Audit Number  
**TO-024-3**

# **SITE AUDIT REPORT** **MARRICKVILLE DIVE,** **MURRAY STREET,** **MARRICKVILLE NSW**

**SITE AUDIT REPORT - MARRICKVILLE DIVE, MURRAY STREET, MARRICKVILLE NSW**

A site contamination audit has been conducted in relation to the Marrickville Dive site of the Sydney Metro City and South West, which is located at Murray Street, Marrickville.

TITLE: **Test Locations, Sydney Metro City & South West, Tunnel and Station Works Package, Proposed Marrickville Dive, Murray Street, MARRICKVILLE**

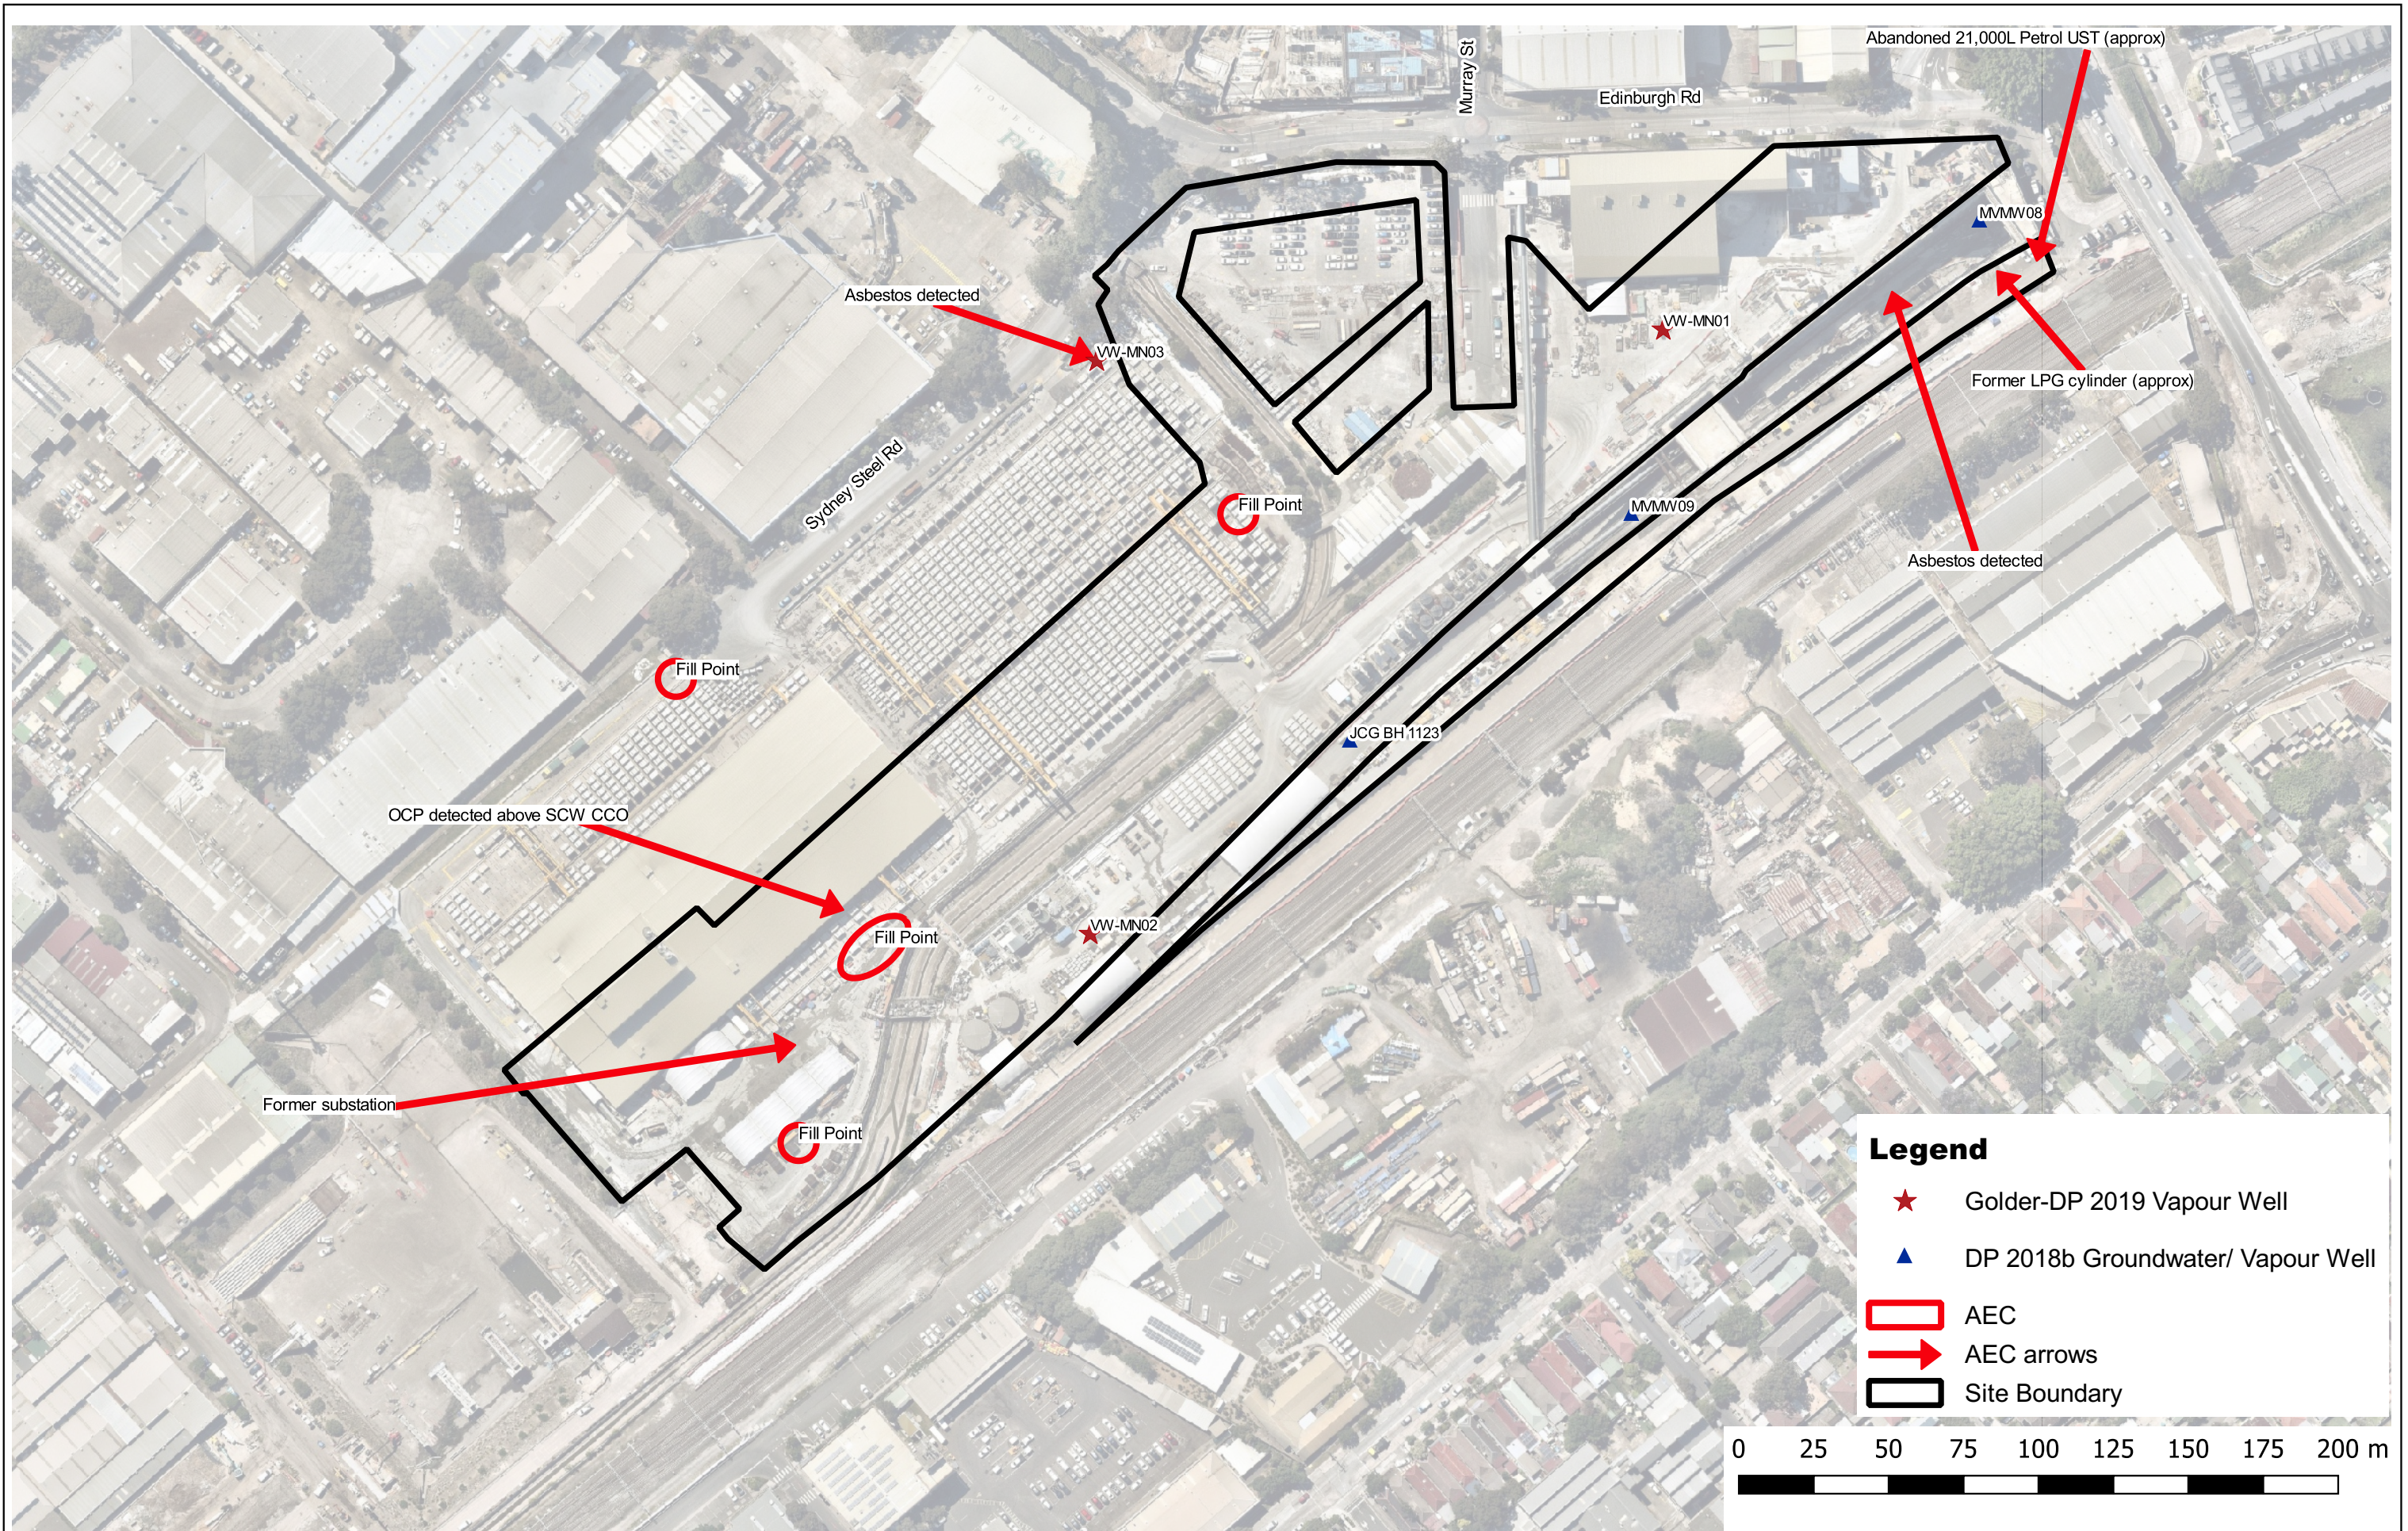
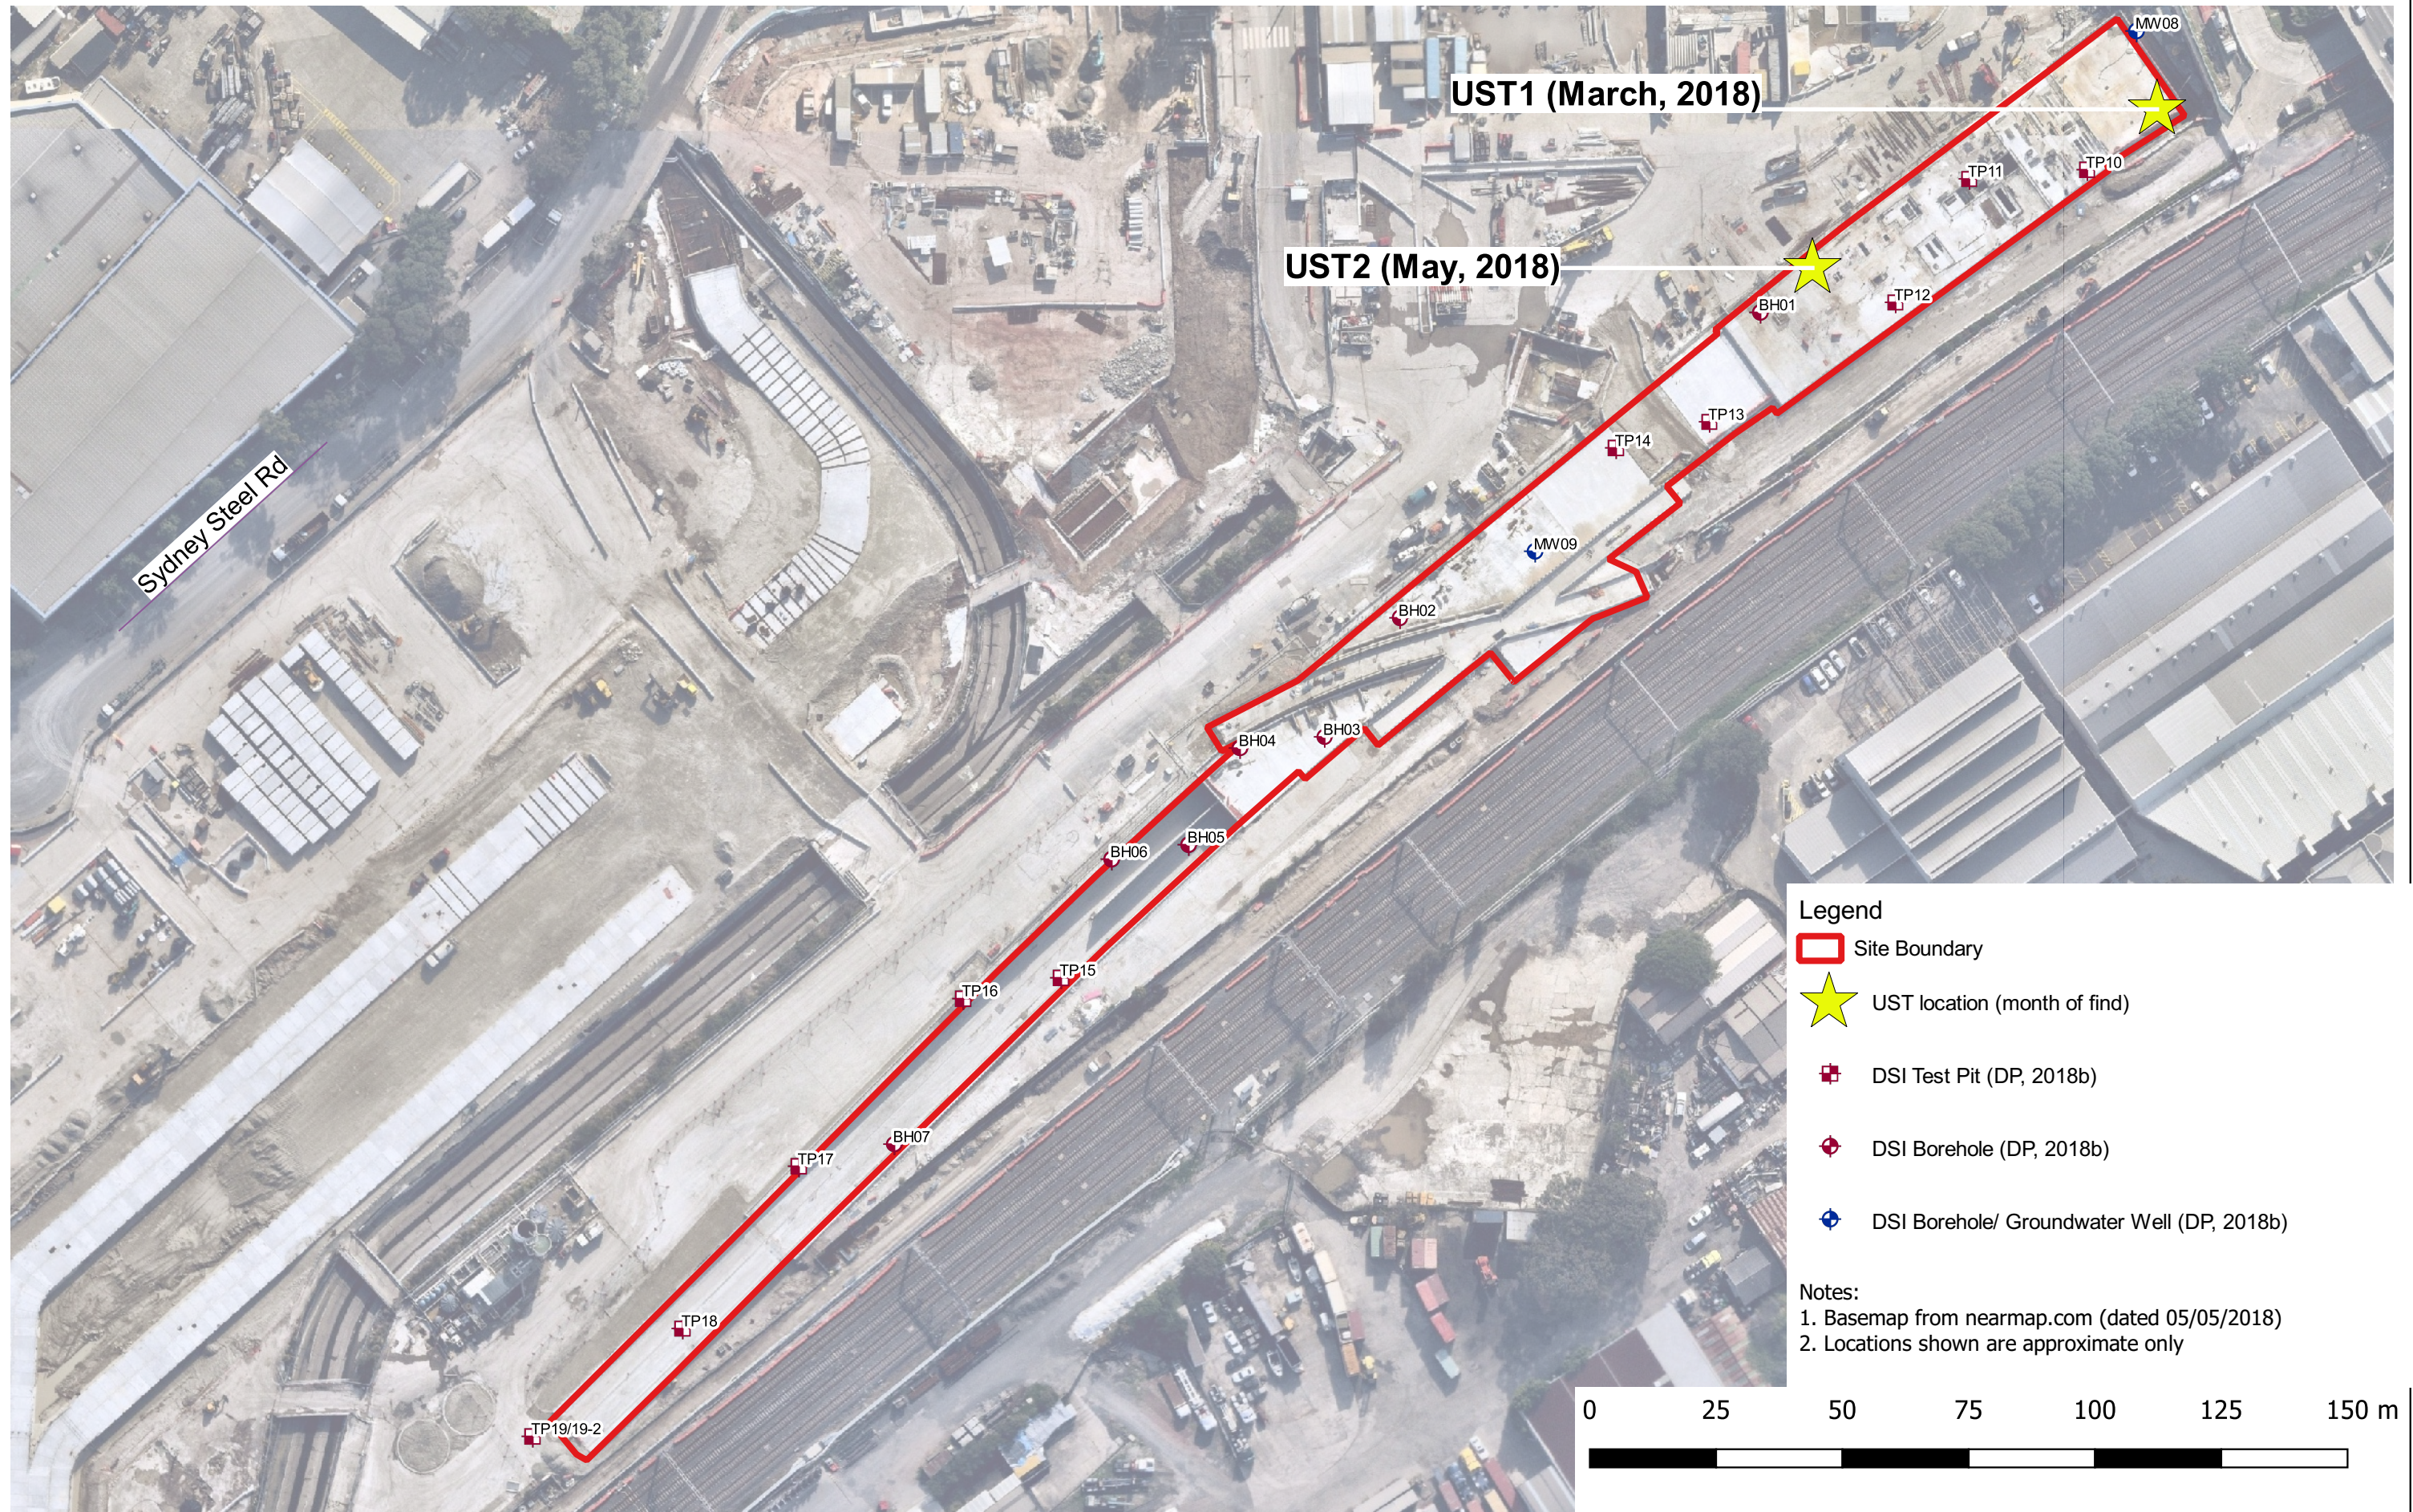
<p><b>Sampling density</b></p> <p><i>Soil:</i> The DSI included a sampling density of 19 locations (see Drawing 2 in attachments) over approximately 0.8 ha, which meets the minimum recommended by EPA (1995) <i>Sampling Design Guidelines</i>. The coverage provides a 95% confidence of detecting a residual hot spot of approximately 24 m diameter.</p> <p>Samples analysed for asbestos were not collected in accordance with the density outlined in NEPM (2013) (Schedule B1).</p> <p><i>Groundwater:</i> A total of 3 groundwater samples were obtained from the monitoring wells at the site.</p>	<p>In the Auditor's opinion the sampling density was appropriate. Considering that the fill from the entire site would be excavated and disposed off-site as part of the development, the sampling adopted by DP is acceptable to assess the presence/absence of asbestos in soil.</p> <p>HGG sampling for laboratory analysis was not undertaken for the DSI. Considering the relatively low risk of HGG migrating onto the site, the field screening was acceptable.</p>
